# Access Compliance Report

## Public Rights-of-Way

### (Curb Ramps)

Intersection ID: 10038340	Main Street: SOUTH_BV	Cross Street: N/A	Location: N
ADA ID: BE5F79E5F192	Ramp Type: Para	Initial Pass/Fail: Fail	Overall Compliance: No
		Severity Score: 12.5

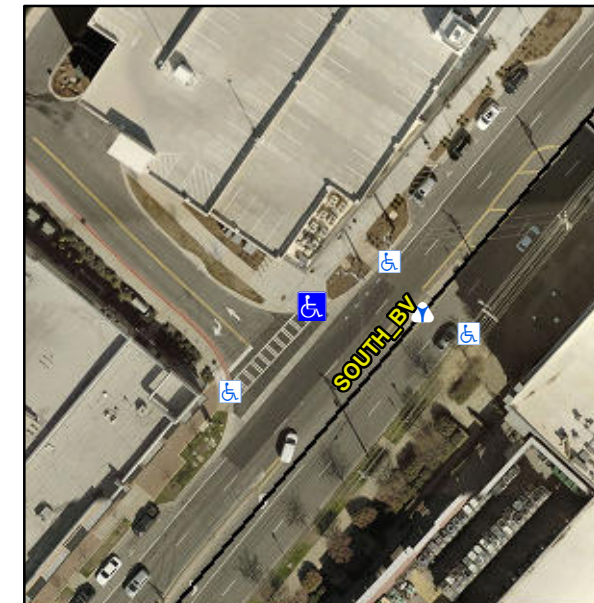
**NO LNDG**

**R304.3.2**

Compliance	Description	Data	Compliance	Description	Data
N/A	Ramp Length LT (in)	67.0	N/A	Ramp Length RT (in)	66.0
Yes	Ramp Width LT (in)	72.0	Yes	Ramp Width RT (in)	71.0
No	Ramp Slope LT (%)	9.4	Yes	Ramp Slope RT (%)	5.1
Yes	Ramp XSlope LT (%)	1.0	Yes	Ramp XSlope RT (%)	1.7
N/A	Landing Length (in)	N/A	N/A	DWS Provided?	N/A
N/A	Landing Width (in)	N/A	N/A	DWS Contrast?	N/A
N/A	Landing Slope (%)	N/A	N/A	DWS Length (in)	N/A
N/A	Landing X Slope (%)	N/A	N/A	DWS Full Width?	N/A
N/A	Landing Curb? (Y/N)	N/A	N/A	DWS Offset (in)	N/A
N/A	Shared Landing?	N/A			
N/A	Gutter Ponding?	N/A	N/A	Gutter Slope (%)	N/A
N/A	Gutter Lip Ht (in)	N/A	N/A	Gutter X Slope (%)	N/A
N/A	Painted X Walk1?	Yes	N/A	Painted X Walk2?	N/A
	X Walk 1 Direction	To SW		X Walk 2 Direction	N/A
N/A	X Walk 1 Width (in)	112.0	N/A	X Walk 2 Width (in)	N/A
	X Walk 1 Slope (%)	0.0		X Walk 2 Slope (%)	N/A
	X Walk 1 X Slope (%)	3.4		X Walk 2 X Slope (%)	N/A
N/A	Ramp inside XWalk1?	Yes	N/A	Ramp inside XWalk2?	N/A

**Remove & Replace Entire Ramp.**
